**General Information**  
(see reverse for instructions)

<b>Name of Project</b>	Franklin Hills Estates & Country Club	<b>CGP Tracking No.</b>	IR #20-10	<b>Inspection Date</b>	1/18/2021
<b>Inspector Name, Title &amp; Contact Information</b>	Inspector: David C. McKay, P.E.		Reviewer: David McKay, P.E.		
<b>Present Phase of Construction</b>	Phase 1				
<b>Inspection Location</b> (if multiple inspections are required, specify location where this inspection is being conducted)	Areas of Concern as defined at site walk with wetlands commission				
<p><b>Inspection Frequency</b> (Note: you may be subject to different inspection frequencies in different areas of the site. Check all that apply.)</p> <p><b>Standard Frequency:</b>   <input type="checkbox"/> Weekly      <input type="checkbox"/> within 24 hours of a 0.5" rain</p> <p><b>Increased Frequency:</b>   <input type="checkbox"/> Every 7 days and within 24 hours of a 0.5" rain (for areas of sites discharging to sediment or nutrient-impaired waters or to waters designated as Tier 2, Tier 2.5, or Tier 3)</p> <p><b>Reduced Frequency:</b></p> <ul style="list-style-type: none"> <li>- <input type="checkbox"/> Once per month (for stabilized are

Photo 1: Stone check dam immediately upgradient of main entry water crossing has flattened due to ATV traffic and has reached capacity with collected sediment.

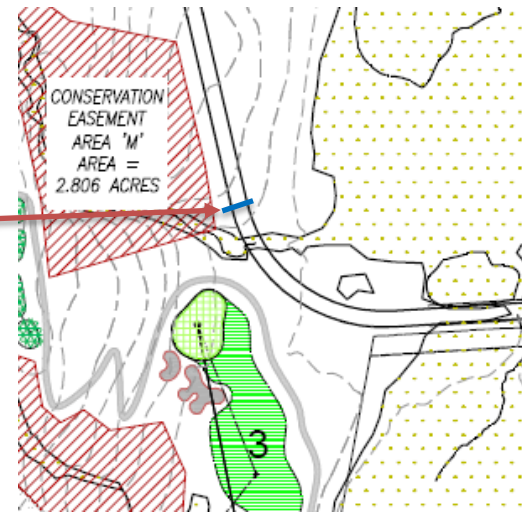
1. Main Entry Water Crossing (Northerly of 3 <sup>rd</sup> Hole Green)	<input checked="" type="checkbox"/> Yes <input type="checkbox"/> No	<input type="checkbox"/> Yes <input checked="" type="checkbox"/> No		Stone check dam immediately upgradient of crossing has been partially flattened due to trespassing ATVs and has reached full capacity (Photo 1). Stone check dam in trail leading down to crossing has reached capacity (Photo 2). Both check dams need accumulated sediment removed and minor repair. Additional check dams could be added along the trail could be added to address channelized flow in tire ruts.

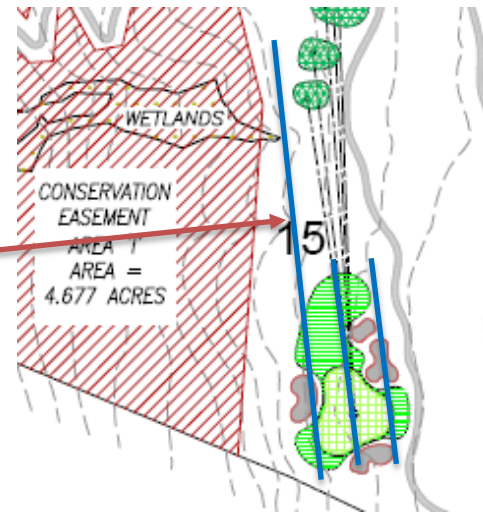
Photo 3: Some sediment fence repairs are needed for undermining at upper and lower sediment fence rows. Undermined areas should be reinforced with stone check dams. Intermediate sediment fence through sapling stand is beginning to fail and should be re-staked. Sediment should be removed from check dams.

Photo 4: Staked hay bales and sediment fence in area shown have failed/deteriorated. There is erosion under the erosion control mat. Check dams should be added to replace deteriorated erosion control measures. Collected sediment should be removed.

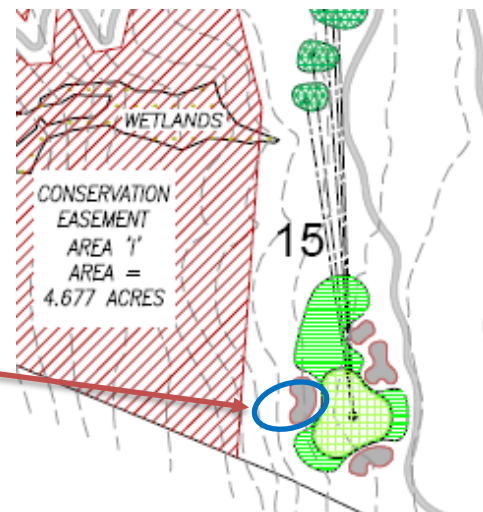
2. 15 <sup>th</sup> Green Sediment Barriers	<input checked="" type="checkbox"/> Yes <input type="checkbox"/> No	<input type="checkbox"/> Yes <input checked="" type="checkbox"/> No		Downgradient stone check dam remains in good condition. Sediment fence along the cart path and along the tree line have undermined in several locations each and should be repaired or reinforced with stone check dams. Southern check dams should have collected sediment removed. Intermediate fence needs to be re-staked. (Photo 3). Sediment fence rows and staked hay bales in south end have deteriorated and need to be replaced (Photo 4).

Photo 5: Stone check dams and staked hay bales are in good condition. Collected sediment should be removed and sediment fence repaired.

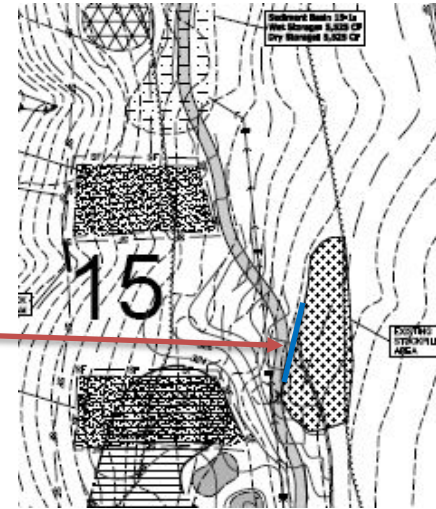
3. 15 <sup>th</sup> Fairway Sediment Barriers	<input checked="" type="checkbox"/> Yes <input type="checkbox"/> No	<input type="checkbox"/> Yes <input checked="" type="checkbox"/> No		Stone check dams, stone apron are in good condition and functioning as intended. Collected sediment should be removed (Photo 5). Sediment fence has been downed and should be repaired.

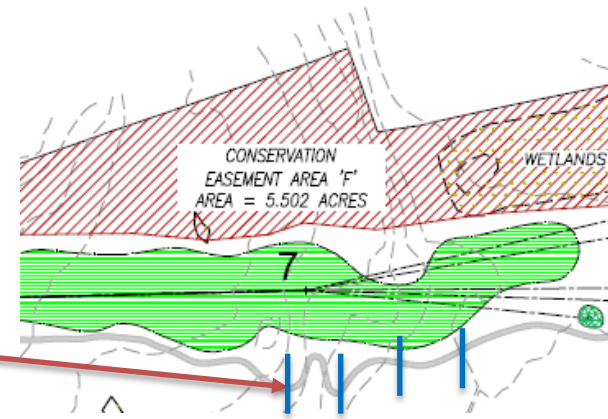
5. 7 <sup>th</sup> Hole Fairway Hillside	<input checked="" type="checkbox"/> Yes <input type="checkbox"/> No	<input type="checkbox"/> Yes <input checked="" type="checkbox"/> No		Check dams across 7 <sup>th</sup> Hole fairway are in good condition overall and functioning as intended (Photo 7). Sediment fence has failed in several locations however given the upgradient vegetation failed sediment fence could be replaced with stone check dams instead of repairing.

Photo 7: Stone check dams across the 7<sup>th</sup> hole fairway hillside remain in good condition. Sediment fence rows and hay bales have deteriorated. Since upgradient areas are vegetated the sediment fence could be replaced with additional stone check dams to prevent erosion from channelized flows.

Photo 8: Sediment fence row across 11<sup>th</sup> hole tee box area has been knocked over by ATV traffic. Remove collected sediment from check dam.

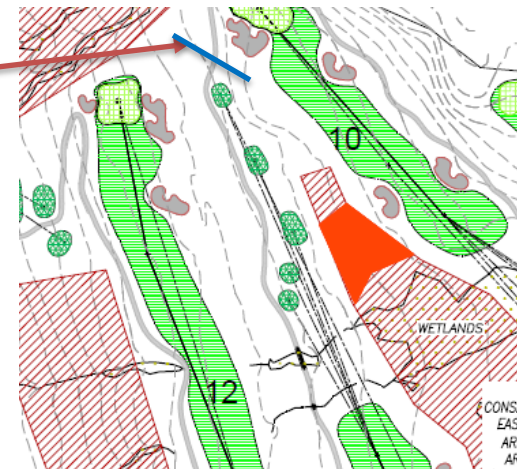
6. 11 <sup>th</sup> Hole Tee Box Area	<input checked="" type="checkbox"/> Yes <input type="checkbox"/> No	<input type="checkbox"/> Yes <input checked="" type="checkbox"/> No		Sediment fence row across path by 11 <sup>th</sup> Hole tee box has failed due to ATV traffic (Photo 8). At time of inspection the area was stable except for tracking and rutting due to ATV traffic. Stone check dams could be installed across ATV track to disrupt channelized flow. Existing stone check dam needs removal of collected sediment.

Photo 9: Sediment fence at tree line by 14<sup>th</sup> hole is allowing flow underneath in two location and should be repaired and reinforced with a stone check dam. An additional stone check dam could be added upgradient of protected area to disrupt channelized flows.

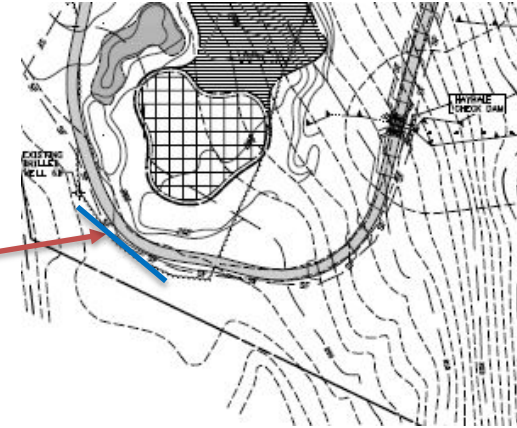
7. 14 <sup>th</sup> Hole Green Sediment Barriers	<input checked="" type="checkbox"/> Yes <input type="checkbox"/> No	<input type="checkbox"/> Yes <input checked="" type="checkbox"/> No		Sediment fence row at tree line is allowing flow underneath in two locations and needs to be corrected (Photo 9). Additional flow paths have begun along the cart path and a stone check dam should be added at the undermined sediment fence.
